### **LADOT Assessment Letter**

1220-1246 S Hope St  
DOT Case No. CEN20-50464

Subject: **UPDATED TRANSPORTATION ASSESSMENT FOR THE PROPOSED MORRISON HOTEL MIXED-USE DEVELOPMENT AT 1220-1246 SOUTH HOPE STREET AND 427-435 WEST PICO BOULEVARD (ZA-2018-2293-MCUP-CUX-ZV-DD-SPR/ENV-2018-2294-EIR)**

FIGURE 2a

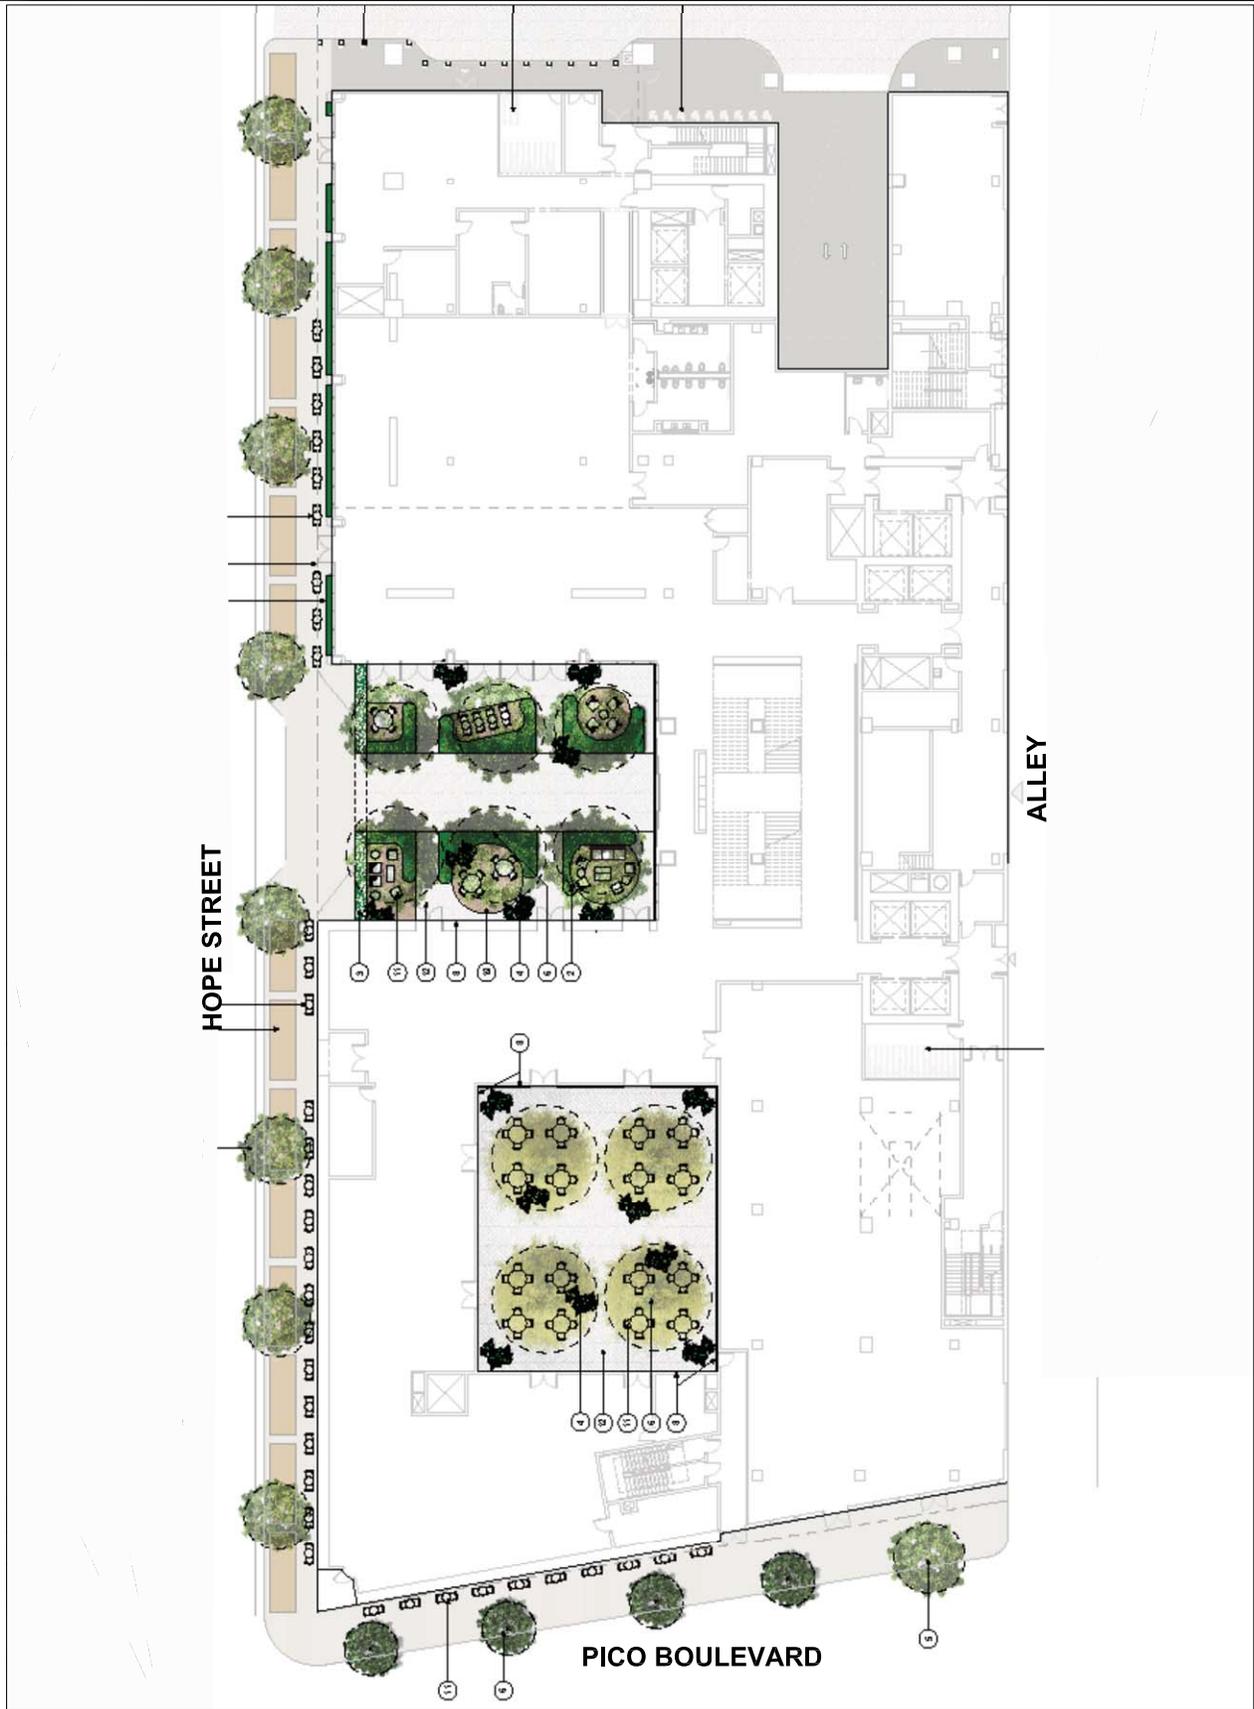
As illustrated in **Attachment A**, the project will be accessed via an ingress driveway on Hope Street and the adjacent north-south alley. Additionally, the project will provide valet services at four locations: full-service along the partially covered driveway aisle for residents; drop-off along the Hope Street PLZ for guests of the hotel, museum, and restaurants/lounges; pick-up along the alley for hotel guests; pick-up near the alley and Pico Boulevard for museum guests; and pick-up along the Hope Street PLZ for the restaurant/lounge guests.

The conceptual site plan is acceptable to LADOT; however, the review of this study does not constitute approval of the driveway dimensions, access and circulation scheme. As illustrated in **Attachment A**, the project will be accessed via an ingress driveway on Hope Street and the adjacent north-south alley. Additionally, the project will provide valet services at four locations: full-service along the partially covered driveway aisle for residents; drop-off along the Hope Street PLZ for guests of the hotel, museum, and restaurants/lounges; pick-up along the alley for hotel guests; pick-up near the alley and Pico Boulevard for museum guests; and pick-up along the Hope Street PLZ for the restaurant/lounge guests. Two on-site loading docks will also be accessed via the north-south alley. Any changes to the project’s site access, circulation scheme, or loading/unloading area after issuance of this report would require separate review and approval and should be coordinated as soon as possible with LADOT’s Citywide Planning Coordination Section (201 North Figueroa Street, 5th Floor, Room 550, at 213-482-7024). The applicant should check with City Planning regarding the project’s driveway placement and design.

The PLZ on Hope Street would require the permanent removal of metered parking spaces and payment to LADOT for lost parking meter revenues or Meter Revenue Recovery (MRR) fee. The MRR fee is based on the revenue collected over twelve continuous months for each removed parking meter projected over a ten-year period, as determined by LADOT’s Parking Meters
